**RE: Steep Slopes Application for the Danziger Residence,
220 Mt. Hope Blvd, Hastings-on-Hudson, NY**

MEMORANDUM

Subject : Steep Slopes Review
220 Mt. Hope Blvd.
Village of Hastings-on-Hudson, NY

Drawings Reviewed : “Topographic Map”, Dated 2/4/16.
“Site Plan”, Revised 6/13/16, Sheet S-1.
“Slope Analysis & Cross Section”, Revised 6/13/16, Sheet S-2.
“Planting Plan & Details”, Revised 6/13/16, Sheet S-3.
“Stormwater Pollution Prevention & Erosion Control Plan,
Revised 6/13/16, Sheet S-4.

Site Plan

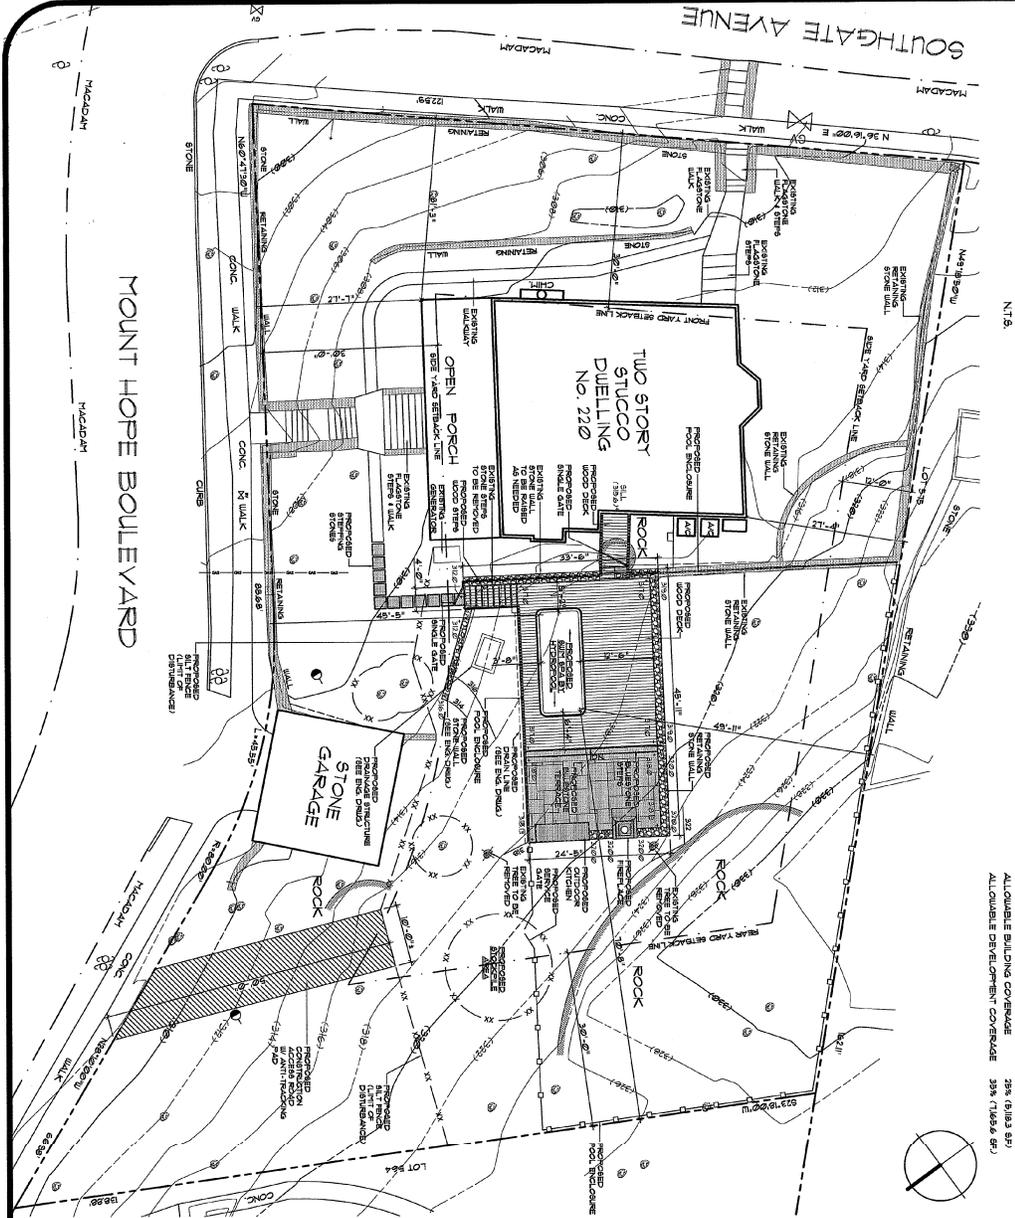
7. All proposed improvements should be highlighted on the site plan using heavier line weights, or the existing site features should be lighter than the proposed.

16. The north arrow on Drawings S-1 and S-4 appear to be in different directions. This should be addressed.
17. Drawing S-4 should be shown at a larger scale for clarity (1"=10').
18. The construction entrance detail on Drawing S-4 does not match the detail on Drawing S-1.
19. The proposed gravel trench shown on S-4 does not appear to match the detail labeled "slot drain". The label for the detail and on the plan should match.
20. The quantity of cut/fill material to be imported/exported should be stated on the plans or provide the following note on the plan:

SLOPE ANALYSIS
 F = 10' = 1"

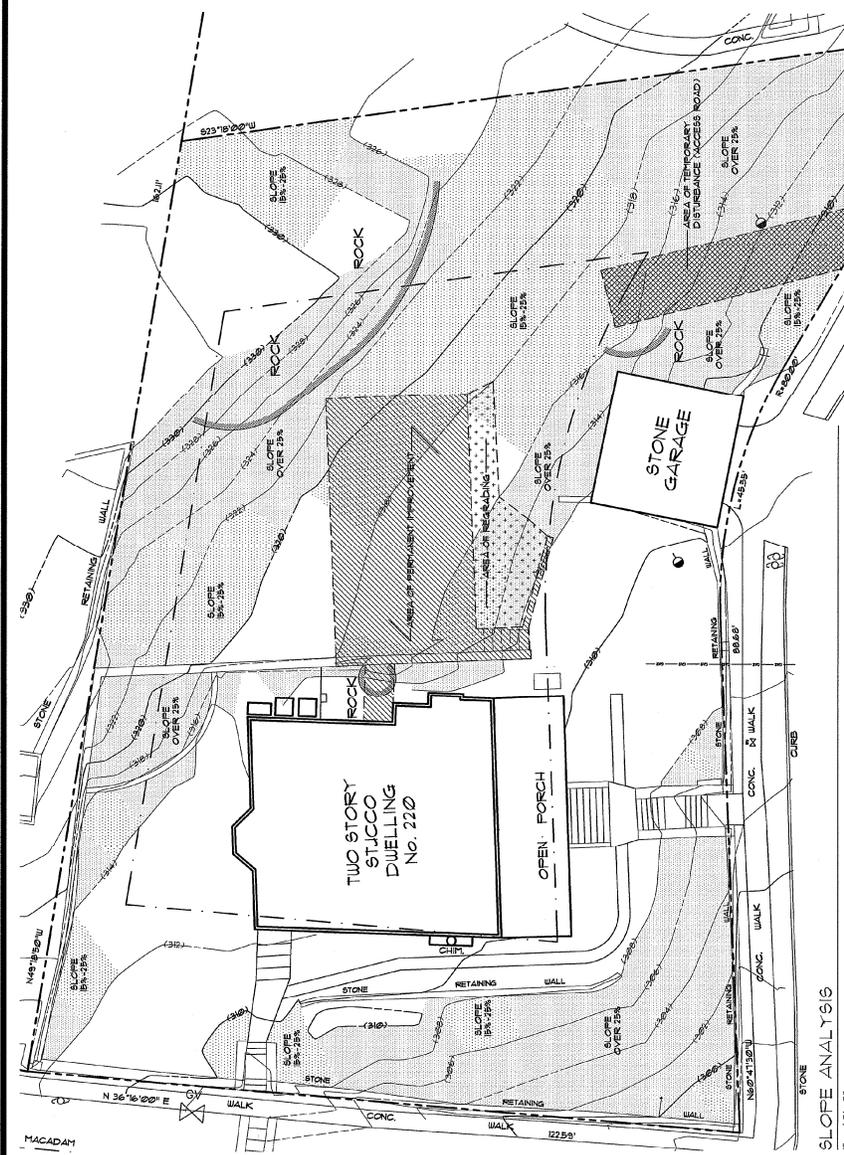
2. The proposed construction entrance will temporarily disturb the steep slope. The potential impact and mitigation should be identified by the applicant. Any temporary grading should be shown along with restoration.
